Product Change Notification

INDUCTIVE COMPONENTS

January, 2008

Change in Thickness and Lead Diameter for Model EMI

Dimensions: mm

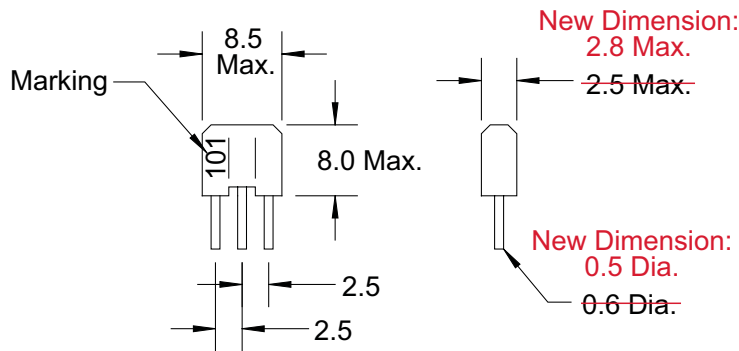
Effective immediately, the following changes will be made to Bourns®/JW Miller® [Model EMI](#), a T network filter:

Thickness: 2.8 mm maximum (Previous value: 2.5 mm maximum)

Lead Diameter: 0.5 mm (Previous value: 0.6 mm)
